PRODUCT CHANGE NOTICE

- PCN Number** : 242
- Product Category** : USB Connectors.
- Issue Date** : 02 - NOV - 2021
- Effective Date** : 02 - NOV - 2021
- LTB Date** : N/A
- LTD Date** : N/A
- Reason For Change** : The shell mold has been updated to support Product production.
- Detail of Change** : Visual and dimensional changes to shell fragment and dimensional changes to the welding foot.
Please see diagram below for details.

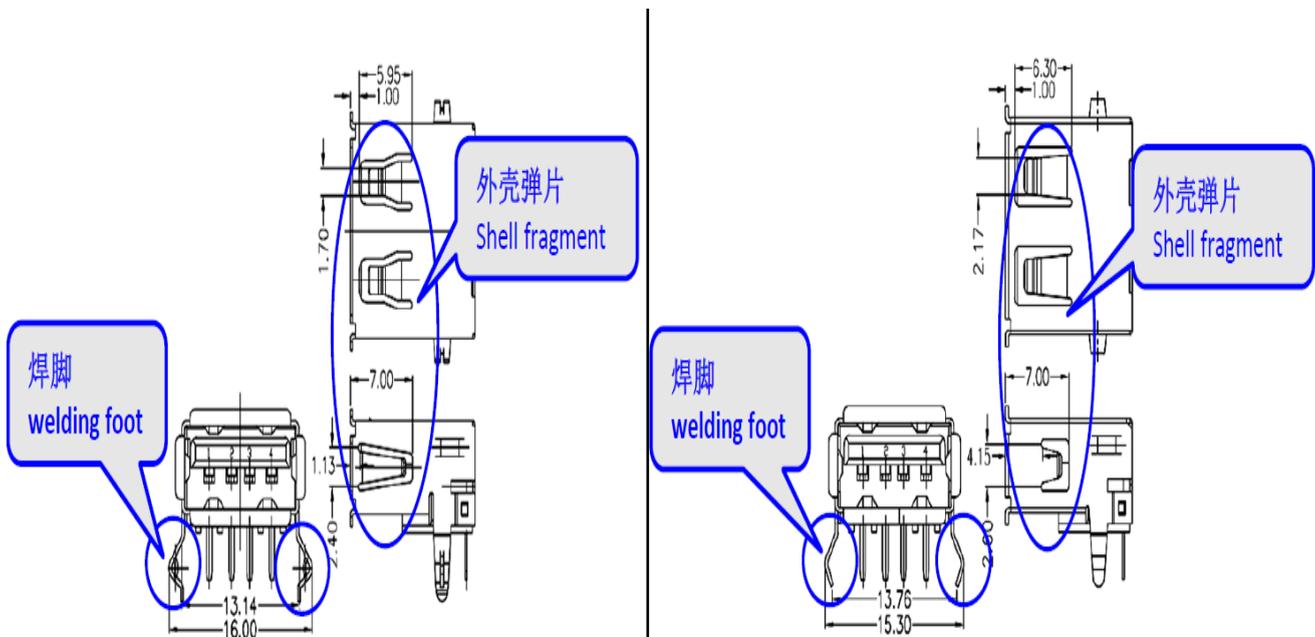
Before Change

After Change
